To: Prospective Bidders

From:
WBRC ARCHITECTS ENGINEERS
44 Central Street
Bangor, ME 04401-5116
(207) 947-4511
www.wbrcae.com

This Addendum forms a part of the Contract Documents and modifies the original Bidding Documents dated August 13, 2021, as noted below. Acknowledge receipt of the Addendum in the space provided on the Bid Form. Failure to do so may subject the Bidder to disqualification.

Project: MeANG Building B493 Re-Roof

PROJECT:
REFLECTED CEILING PLAN

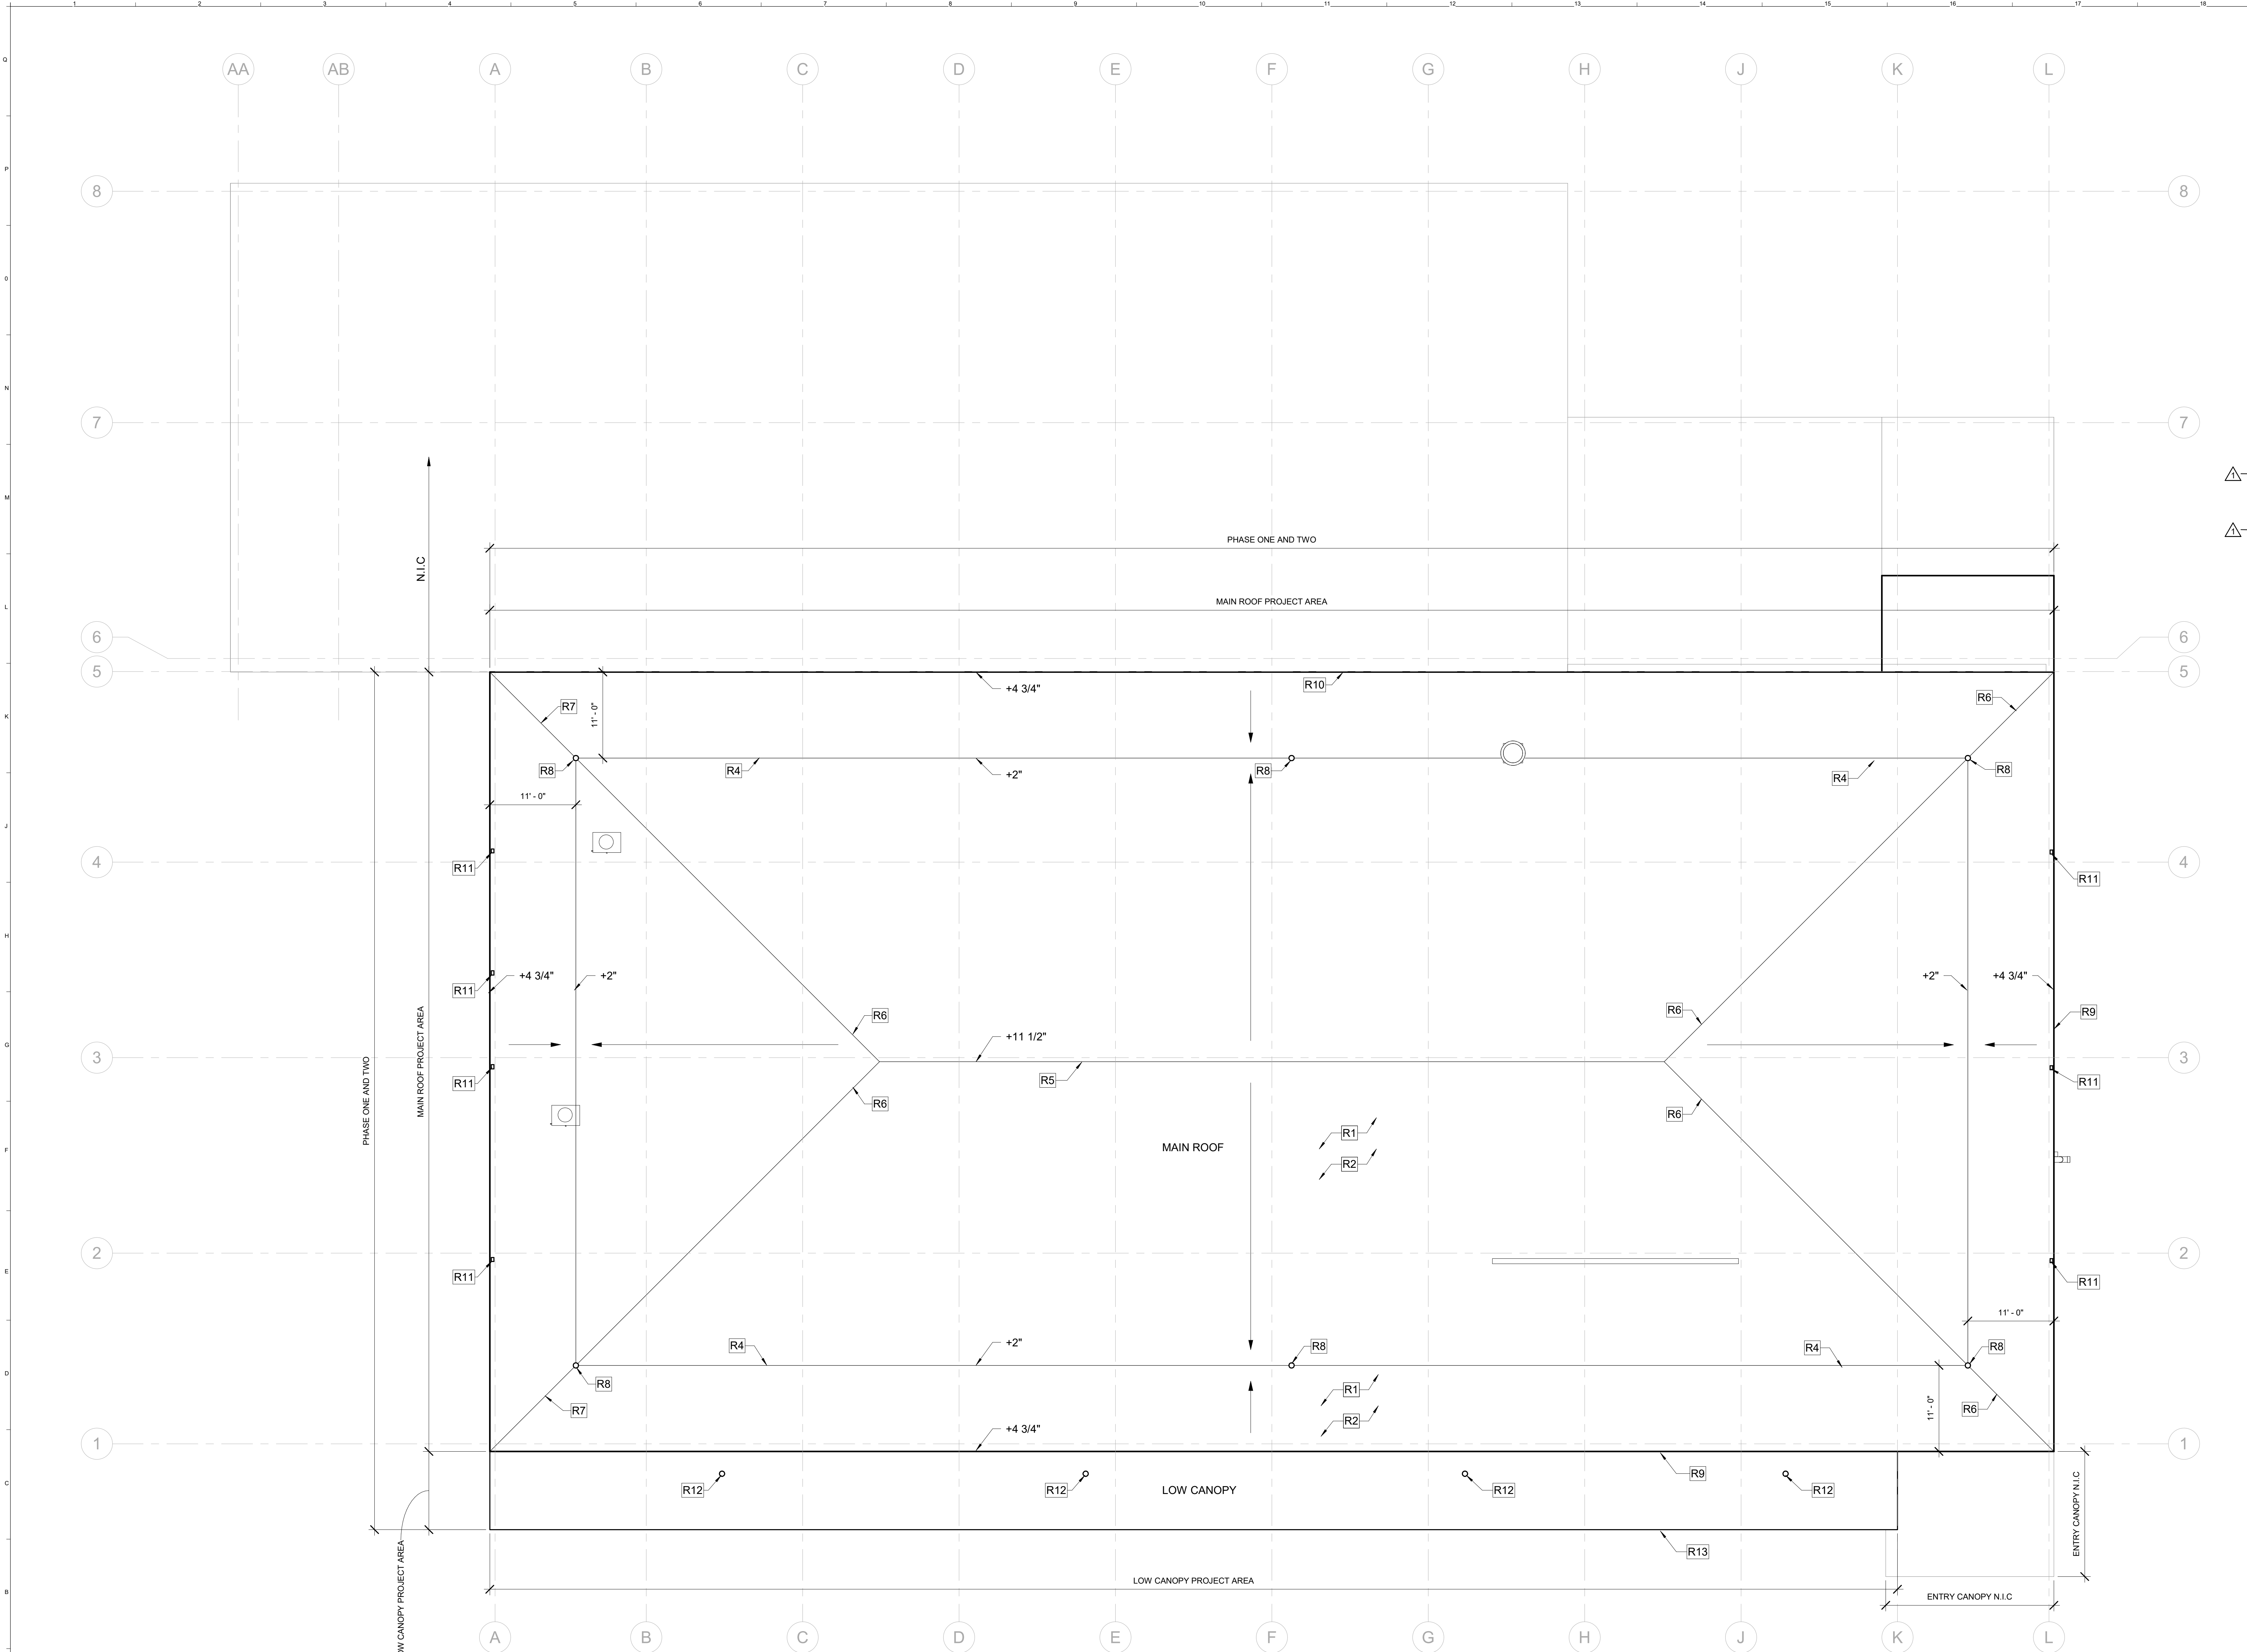
Sheets AE102, AE103, AE501, revisions shown clouded.

DETAILS

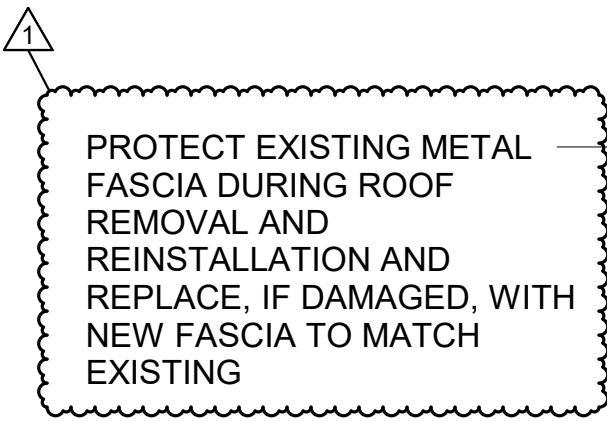
3. Question: You have noted, perimeter flashing on the canopy is to remain. This will get destroyed during the existing roof assembly removal process, as it is part of the existing roof assembly and will not be easily cleaned and/or salvaged.

Answer: The design intent is to protect and retain existing fascia. See revised note on detail A8/AE501, included in reissued drawing set.
